RE: Site Plan Review: Response to Dubois & King Inc.  
John and Linda Svenson & 1962 Real Estate LLC  
Tax Map 235, Lot 1 & Tax Map 239, Lot 2

On behalf of John and Linda Svenson & 1962 Real Estate, Berry Surveying & Engineering (BS&E) is submitting for your review the revised site plan and responses to Dubois & King Inc. for the land at Christmas Lane, off NH Route 9, Tax map 235, Lot 1 and Tax Map 239, Lot 2. We submit a response letter for the comments made by Dubois & King Inc. dated, September 5, 2018. Our Responses are in **bold**.

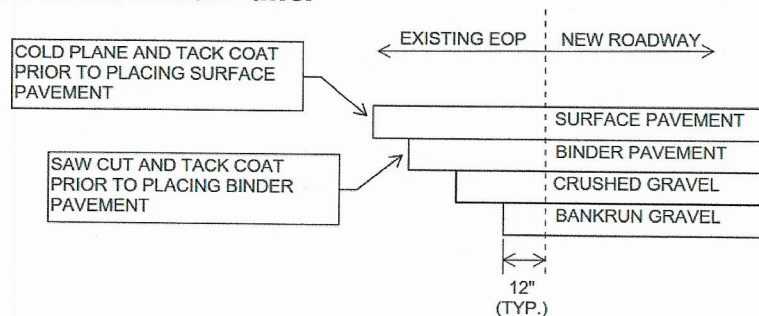
25. We recommend that either a note be included with the underdrain detail stating that the underdrain shall be installed in all cut areas or the applicant determine the location of the underdrain within the cut sections based on documented groundwater elevations in accordance with Barrington Subdivision Regulations Section 12.8.8(7).

**The only locations with major cut slopes are adjacent to the proposed Rain Gardens. As part of the Rain Garden design, 6" underdrains are proposed to ensure that the storm water drains properly. All other cut areas are with for inlet sumps or for the Infiltration ponds. The test pits were done to determine the seasonal high water table. Gravel sections remain above the seasonal high water table.**
